LAND AT PALK ROAD, HAVANT

ADDENDUM TRANSPORT ASSESSMENT

<i>Document No:</i>	043.0035/ATA/2	
<i>Status:</i>	Original	
	<i>Name</i>	<i>Date</i>
<i>Prepared by:</i>	Jessica Miller	September 2023
<i>Checked by:</i>	Tom Fisher	September 2023
<i>Approved by:</i>	Mark Smith	September 2023

<i>Rev.</i>	<i>Date</i>	<i>By</i>	<i>Summary of Changes</i>	<i>Aprvd</i>
2	06.10.23	CID	Clients Comments	JM

Appendix E

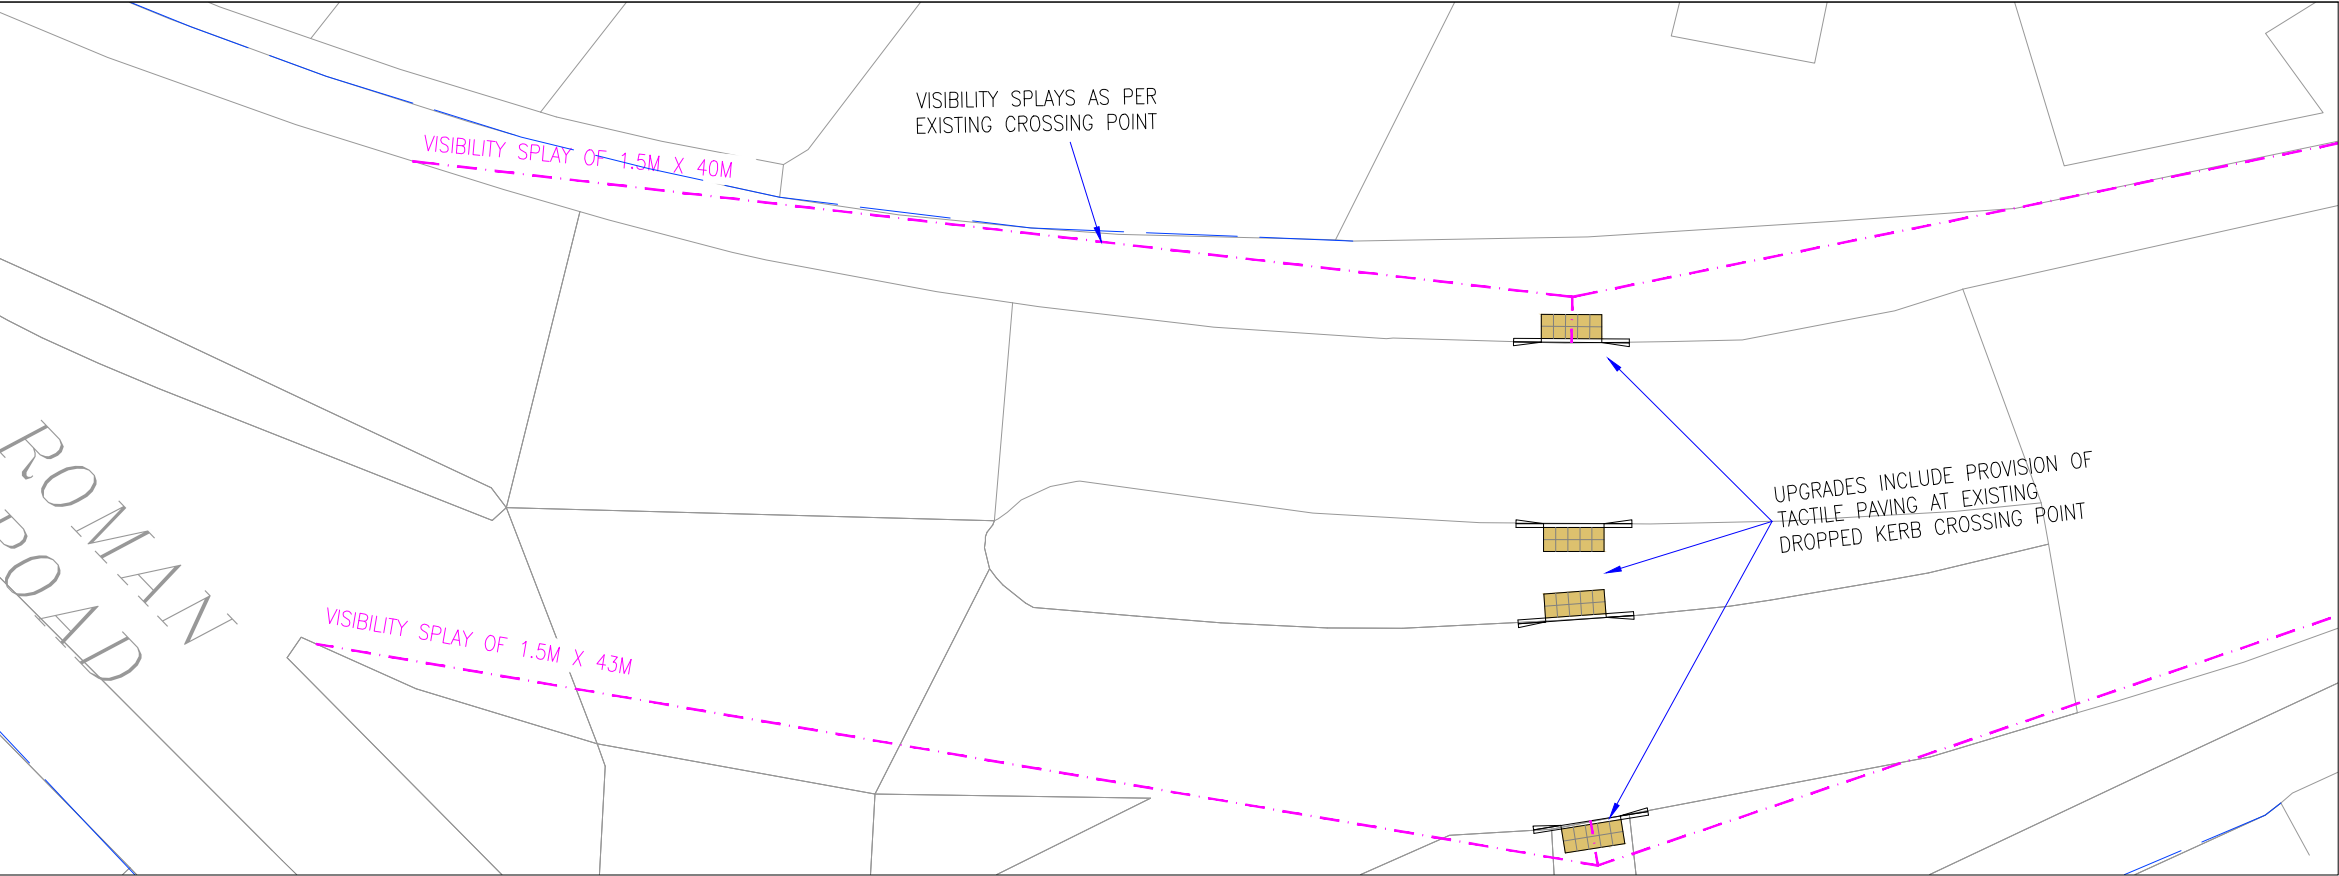
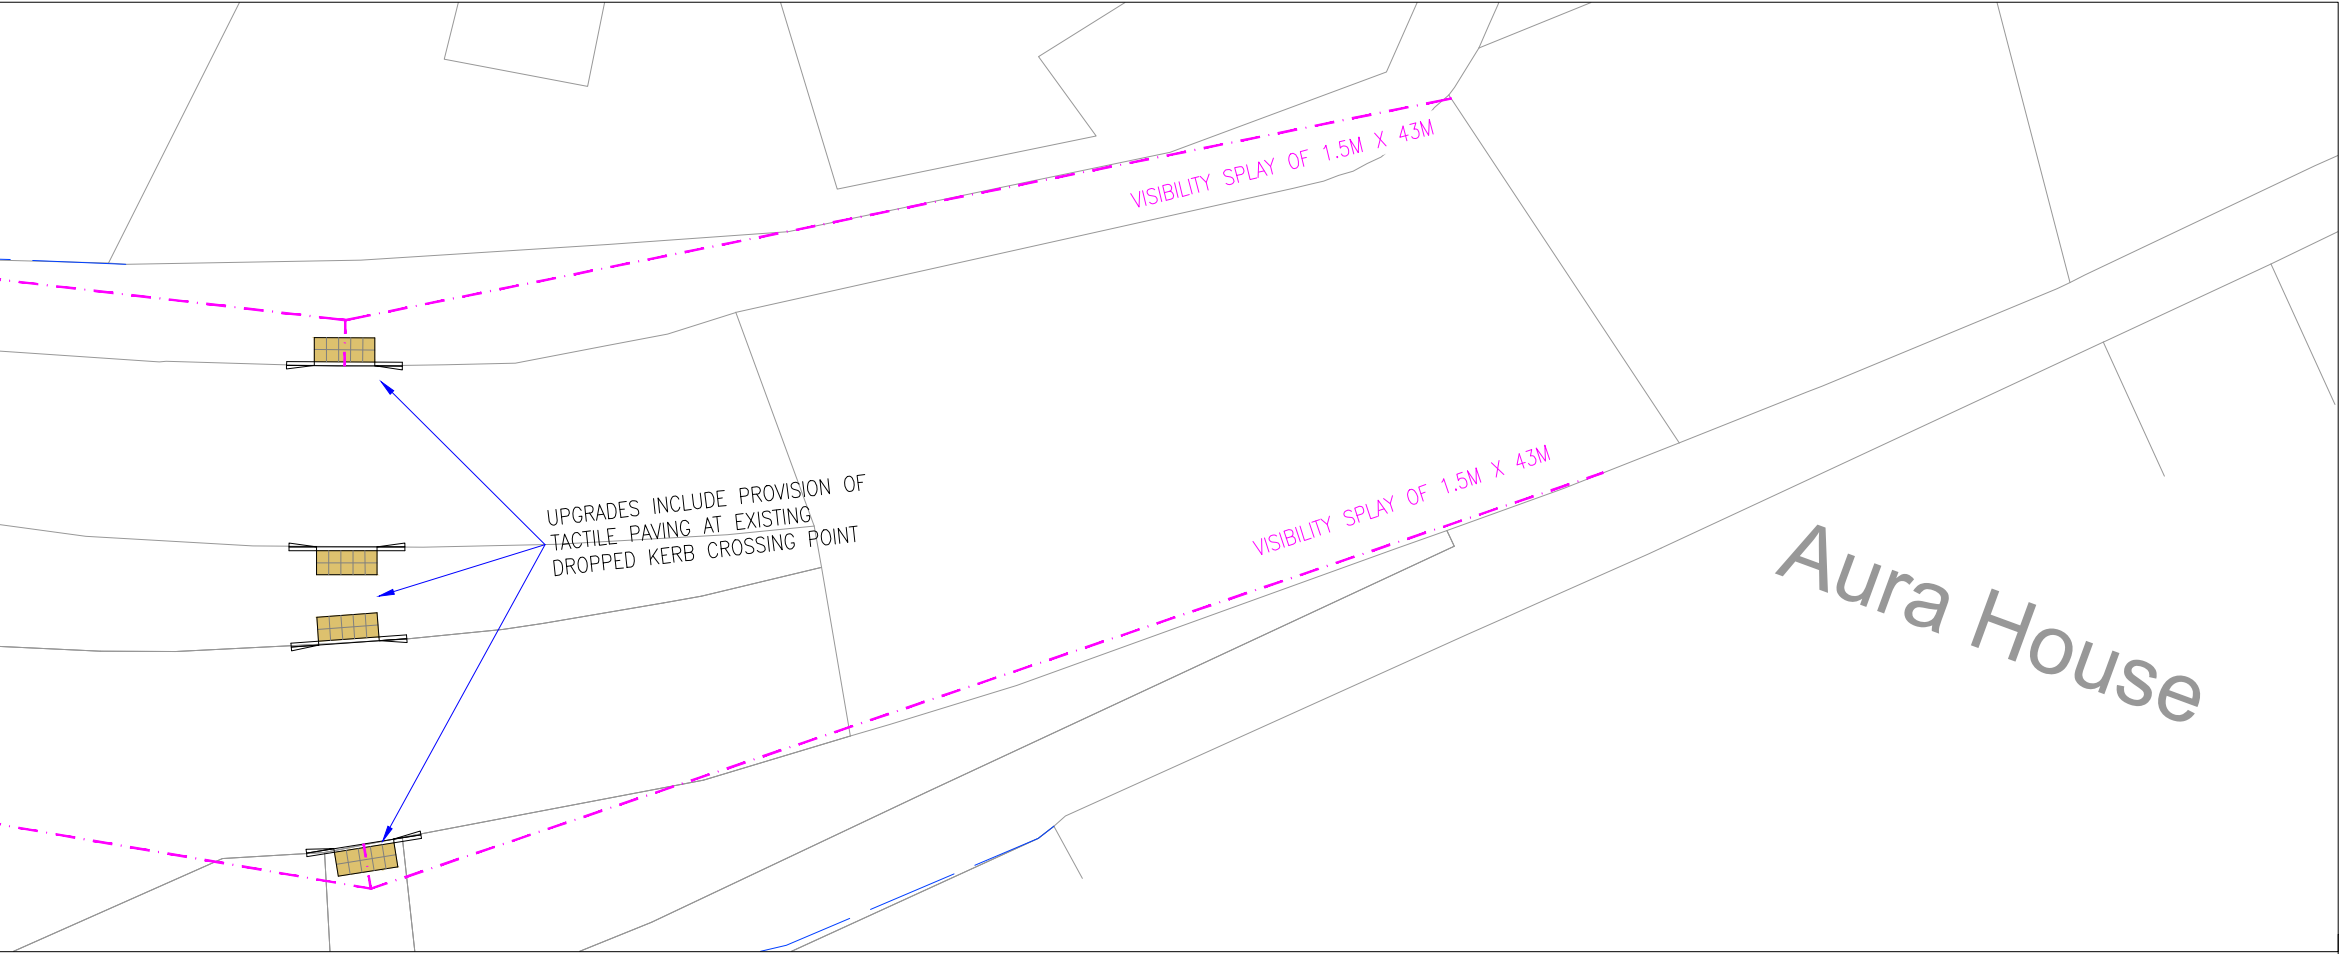
As noted previously within this response, the routing to Bidbury Infant and Junior schools is not agreed and therefore the existing crossing provision identified within the WCHAR is unlikely to be adequate as it does not account for desire lines. From on-site observations, it is noted that pedestrians cross informally utilising the extended central reservations opposite the Bedhampton Road/West Street junction. The Highway Authority aspire to provide a refuge crossing with tactile paving in the vicinity of this junction and North Street to provide a safer crossing point for future residents of the site. The Highway Authority would welcome a discussion with the applicant on this point.

- 2.10 The route to the Bidbury Schools has been reviewed in detail within the updated WCHAR in accordance with HCC comments. An indicative refuge island crossing point has been designed to ensure such a crossing could be deliverable in accordance with standards, this is shown in **Appendix D**. We would

therefore suggest a proportionate contribution is offered to support the delivery of this crossing point which the use of other developments in the area.

Appendix H

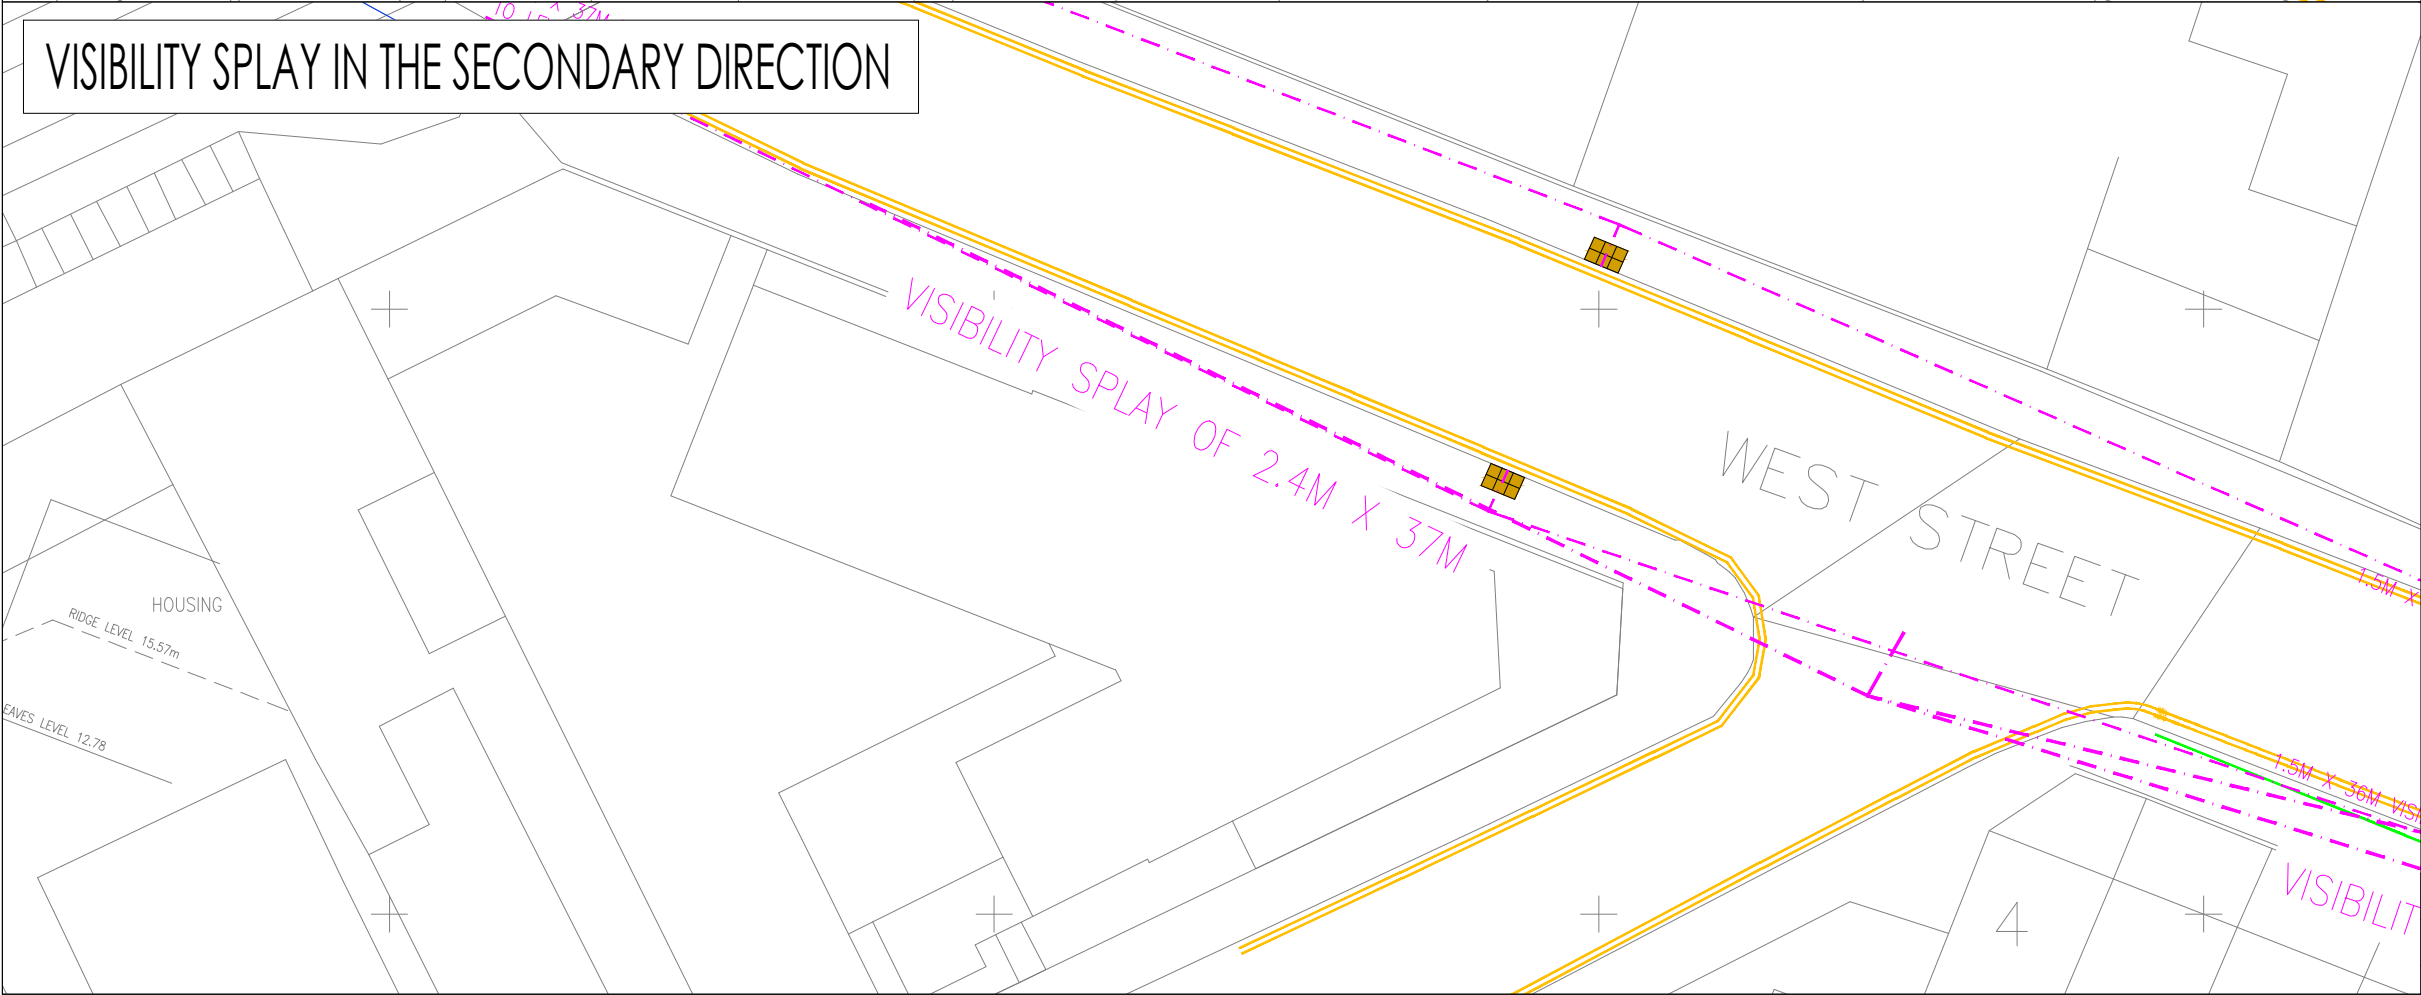
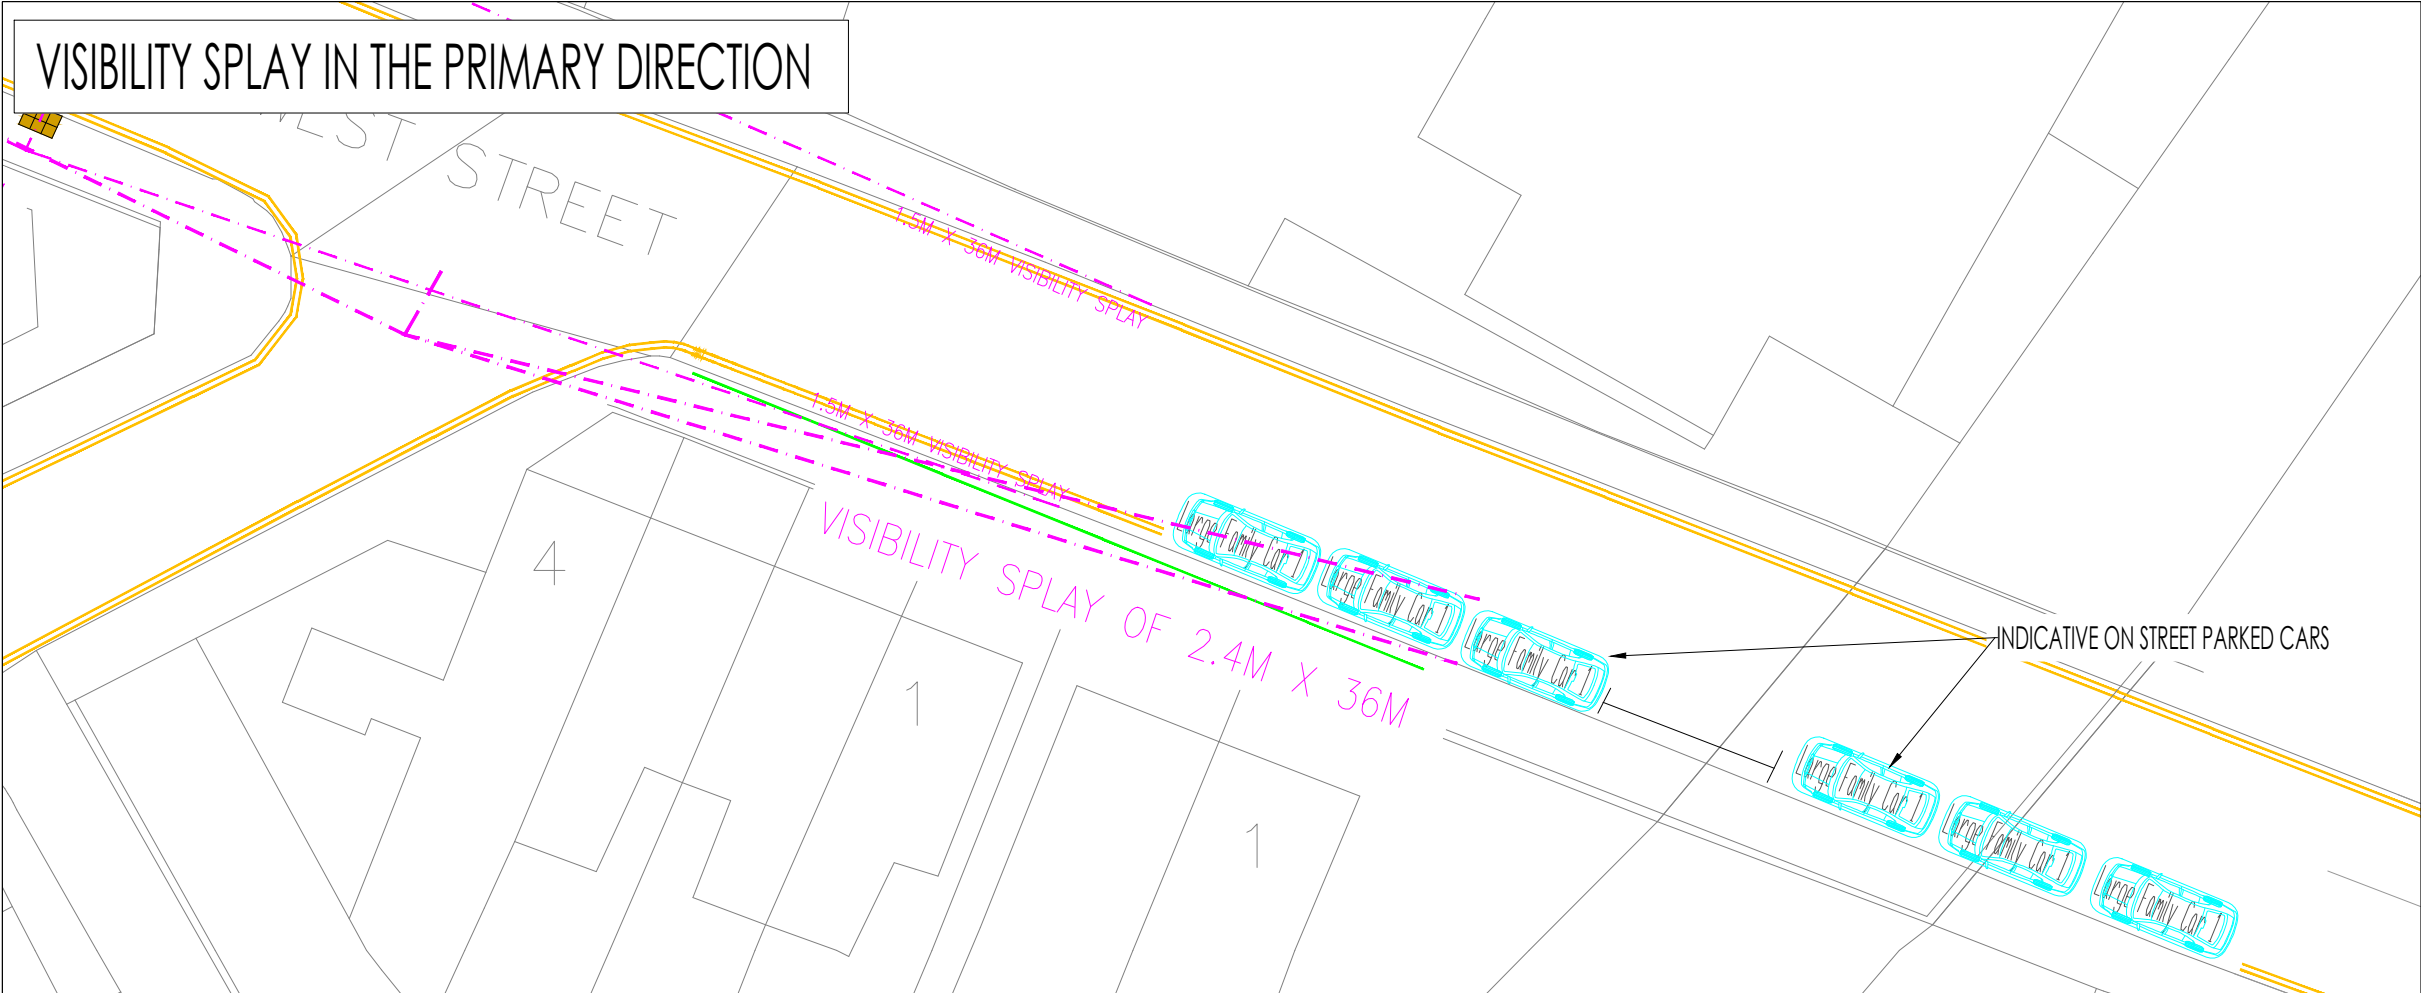
Visibility splays for the Palk Road/West Street junction are shown in drawing 043.0035.002. It is not agreed that visibility is unobstructed in each direction. The existing on-street parking and the pedestrian barrier along West Street in the vicinity of the Palk Road junction does impact the achievable visibility for vehicles existing the junction. It is noted that the visibility has not been assessed based on the HCC TG3 guidance. It is requested that a speed survey is undertaken to confirm the visibility requirements at the Palk Road junction to ensure that appropriate visibility can be achieved in accordance with recorded speeds.

Thus, the achievable visibility is reliant on a TRO to remove existing long-established parking spaces for residents along West Street, which is subject to its own statutory process. The applicant should consider appropriate mitigation to mitigate against the impact of parking loss for these residents which is further discussed within this response.

- 4.1 Visibility splays at the Palk Road/West Street junction have been reviewed against an Automated Traffic Count (ATC) survey completed between 17th -23rd June 2023. The results (attached as **Appendix G**) confirm 85th percentile speeds of 27.1mph eastbound and 26.5mph westbound, based on the 7-day average (which results in higher speeds than 5-day). When using HCC's TG3 calculator this results in visibility splay lengths of 36m in the primary direction and 37m in the secondary direction. A revised visibility splay drawing calculated using the recoded 85th percentile speeds is shown in **Appendix H**.
